Hawaiian Memorial Park Cemetery Expansion Final Environmental Impact Statement

Kāneʻohe, Oʻahu, Hawaiʻi

September 2008
Volume 1

ERRATA SHEET

Figure 29a
Shallow Water Retention Area Profiles
 Hawaiian Memorial Park Cemetery Expansion
 Environmental Impact Statement
 Kāne'ohe, O'ahu, Hawai'i

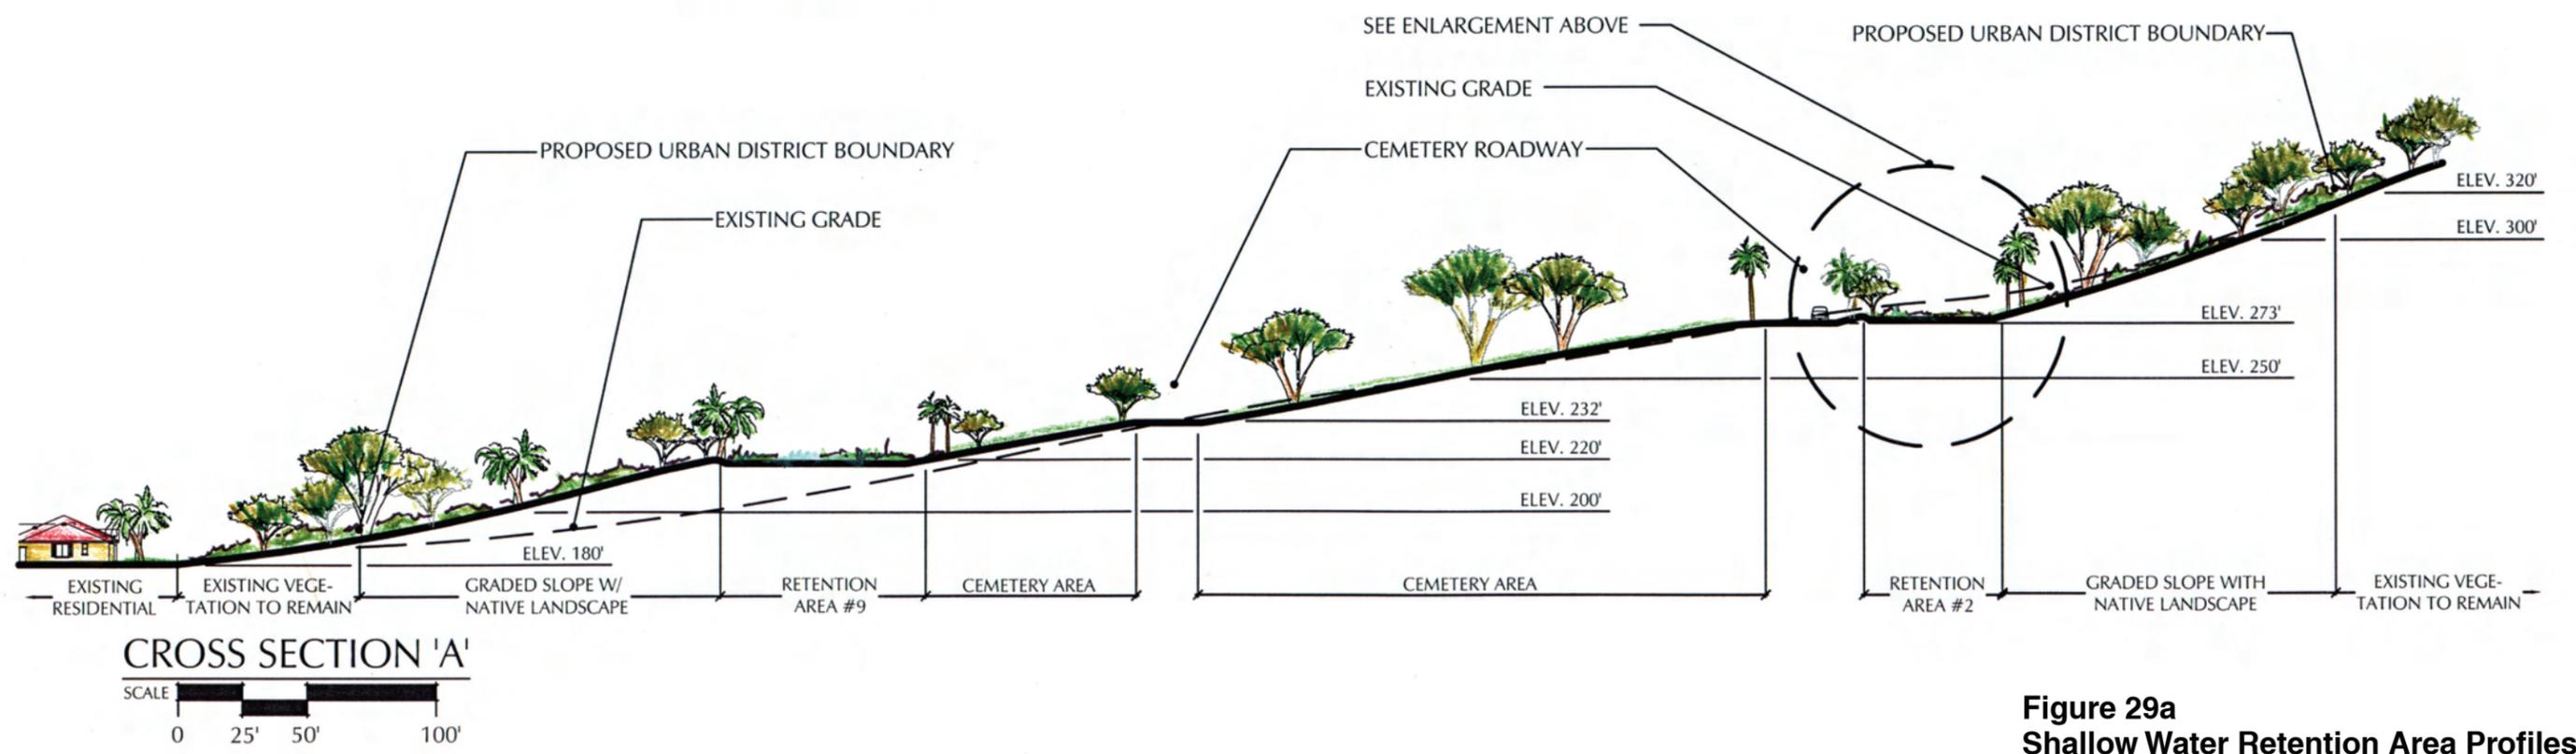
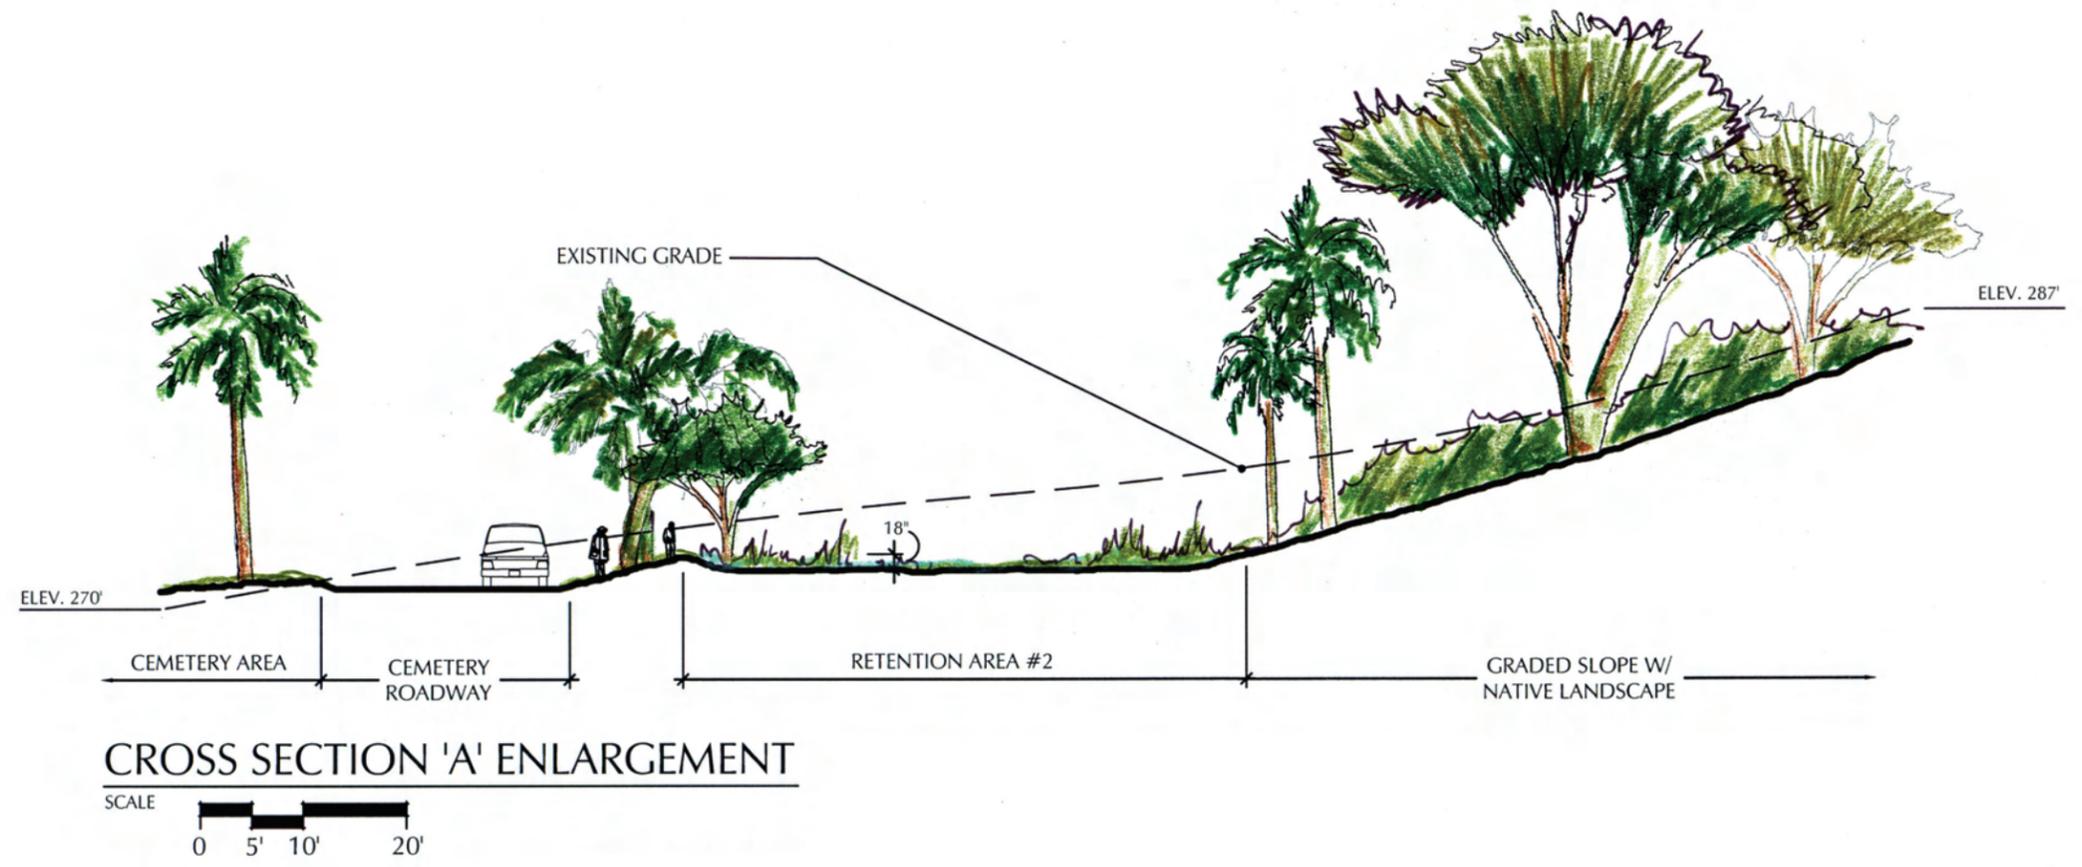
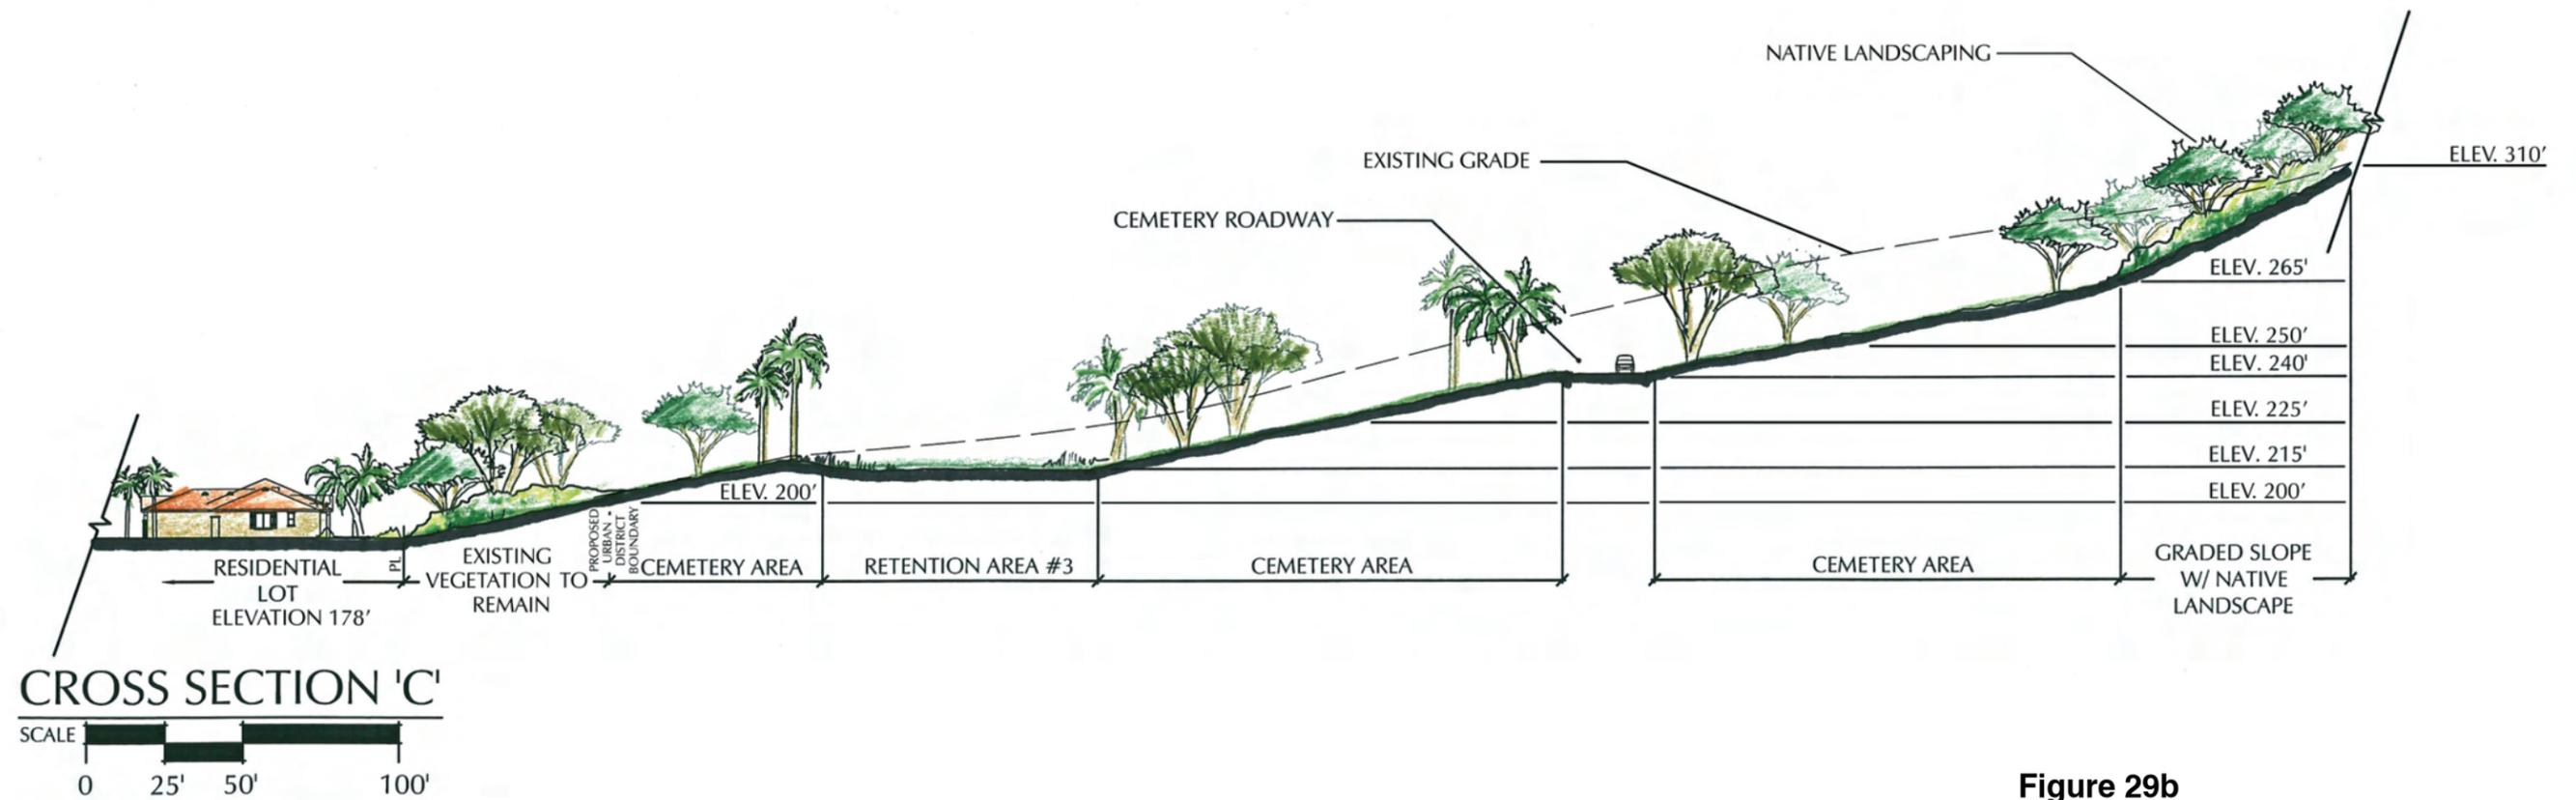
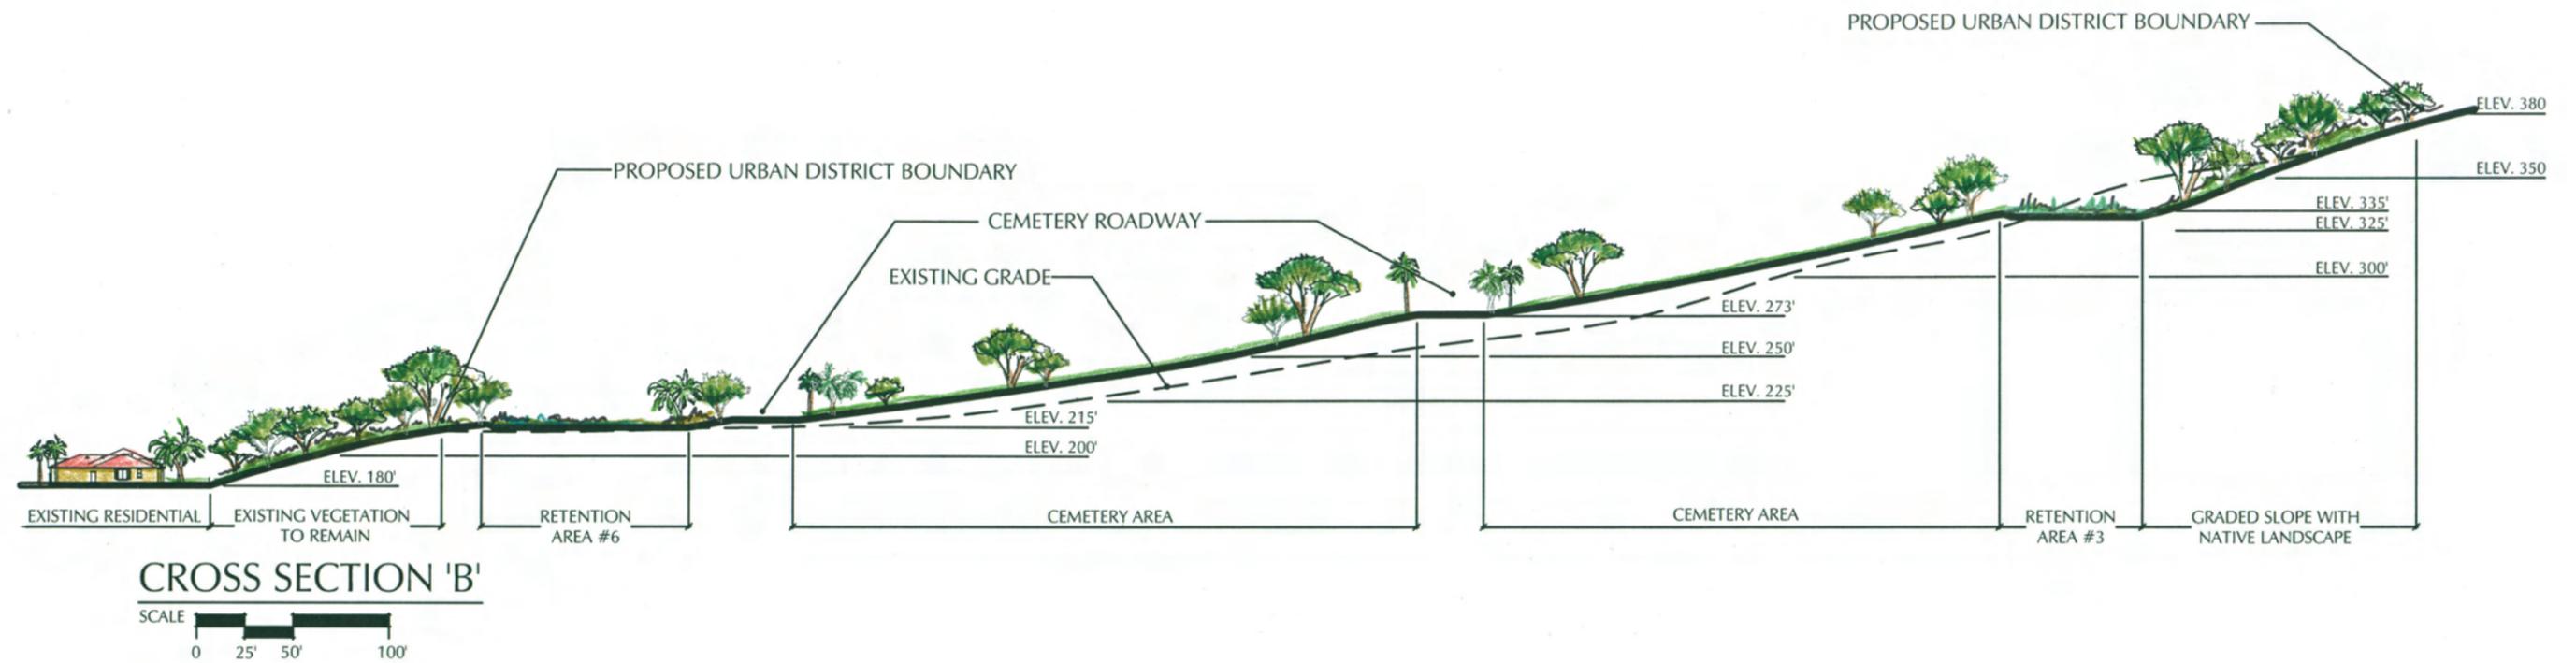
Also, clear illustrations of the proposed cut and fill areas should be provided. We recommend enlarging Figure 22 (an overall before-and-after site view) and providing close-up views (before and after) of Figure 22. Figure 28 a and b should also include cross sections of existing conditions before development. The elevations should be shown on the contour lines of the plans in the EIS.
2. **Scenic and Visual Impacts.** The above recommended illustrations would also make it easier for the reader to understand the discussion of scenic and visual impacts in Section 4.10.2. We recommend that the photos in Figure 23 be enlarged. Views from other vantage points should be included and evaluated such as H-3 Freeway and other sites near and far.

Response: Thank you for pointing out an area of the EIS that was not completely clear. The Final EIS has been changed in several areas to disclose the future topographic profiles. Figures 28a and 28b have been updated to show the existing topographic profile along with the future profile that includes the retention areas and cemetery.
